EVALUATION
OF
REACTOR COOLANT SYSTEM LOADS
AND
COMPONENT SUPPORT MARGINS
RESULTING FROM
OPTIMIZED REACTOR COOLANT PUMP SUPPORT CONFIGURATION

CRYSTAL RIVER 3 GENERATING PLANT

Prepared for
Florida Power Corporation

Babcock and Wilcox, Lynchburg, Virginia

PUMP SUPPORT CONFIGURATION

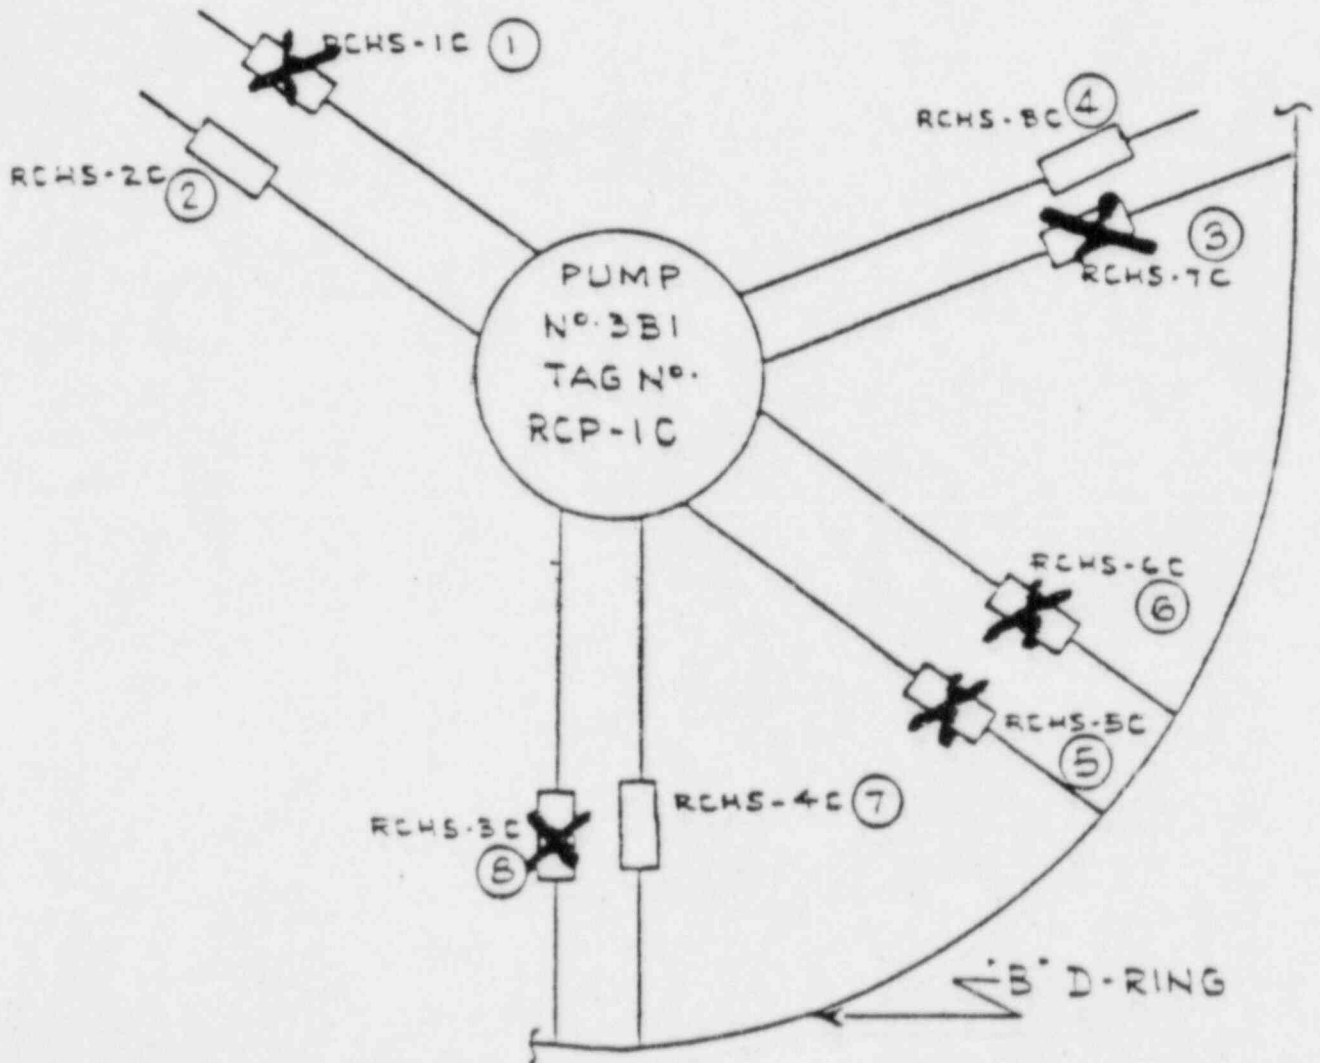
"A" D-RING

SNUBBER ELIMINATED

SNUBBER REPLACED BY
RIGID STRUT

SNUBBER DOWNSIZED
